YANKEE ATOMIC ELECTRIC COMPANY

Subject: Response to the NRC Questions on RELAP5YA

RESPONSE TO 80 QUESTIONS
ON RELAP5YA

July 1, 1985

Figure IX.18-5: Marviken Test 10 Escaped Mass
RELAP5YA Standard Critical Flow Model Predictions

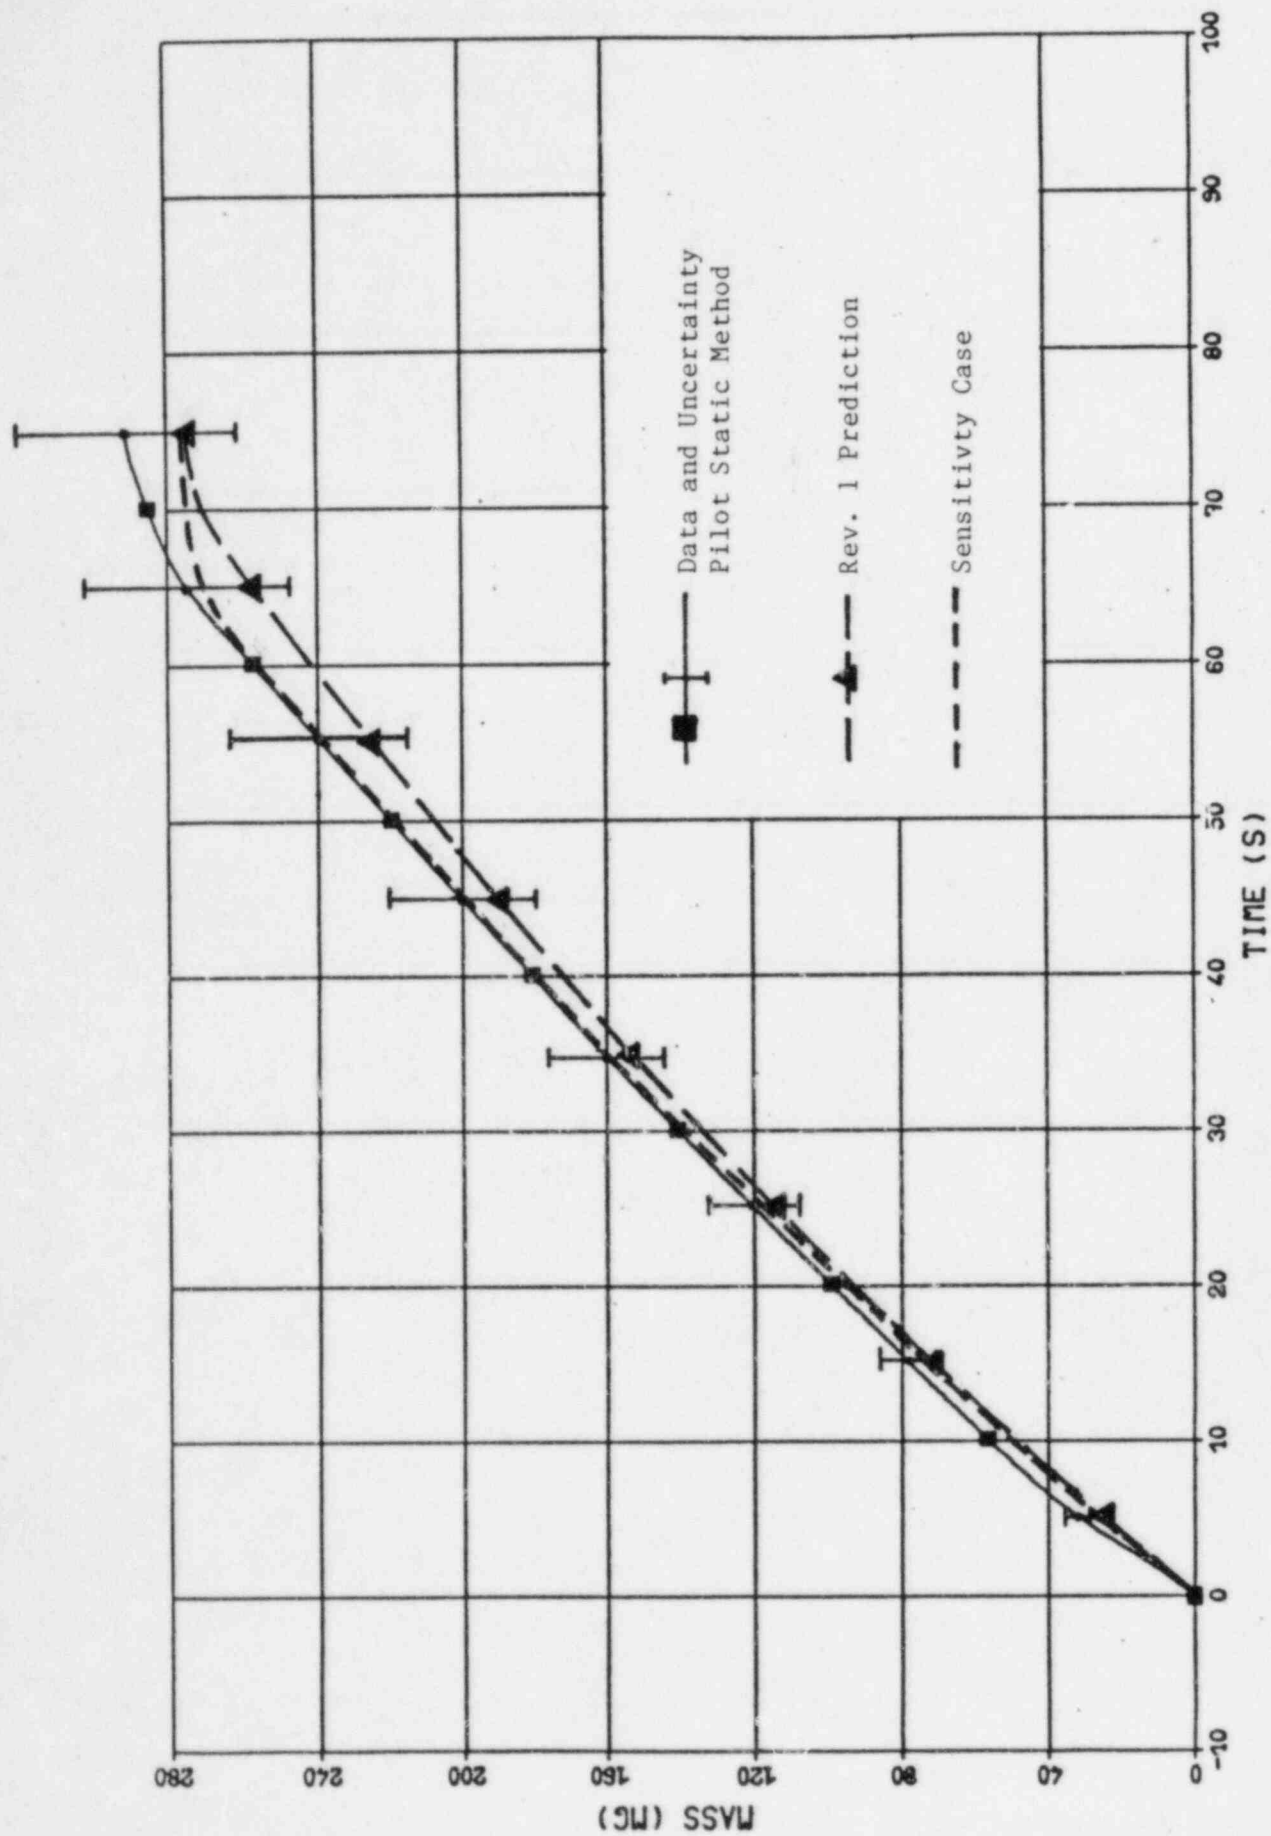
Figure 15 in Appendix A of Reference IX.18-1 shows that the virtual mass coefficient in Equation (149) has a significant effect upon the two-phase equilibrium sonic speed. Thus, this coefficient will have a significant effect upon the mass mean Mach number defined by Equations (148), (149) and (154). Figure 16 (Reference IX.18-1) shows the coefficient, D, defined in Equation (150) that multiplies the relative Mach number is bounded by ± 0.6 . The relative Mach number for critical flow conditions is generally an order of magnitude less than

This observation was checked by rerunning the Marviken Test 10 Best-Estimate Calculation and assuming $C=\infty$ in Equation (150) consistent with the assumed value in Equation (149). The results are shown in Figures IX.18-1 through IX.18-5 as the sensitivity case indicated by the small dash lines. These results show the break flow rate and discharge pipe void fraction are slightly higher. This causes the vessel dome pressure to decrease faster and moves to outside the uncertainty bars on the measured dome pressure. Both the Revision 1 prediction and the sensitivity case predict the escaped mass history within the uncertainty of the reported test data. Therefore, we believe the original model given by Equation (245) remains the best model to use for critical flow calculations at this time.
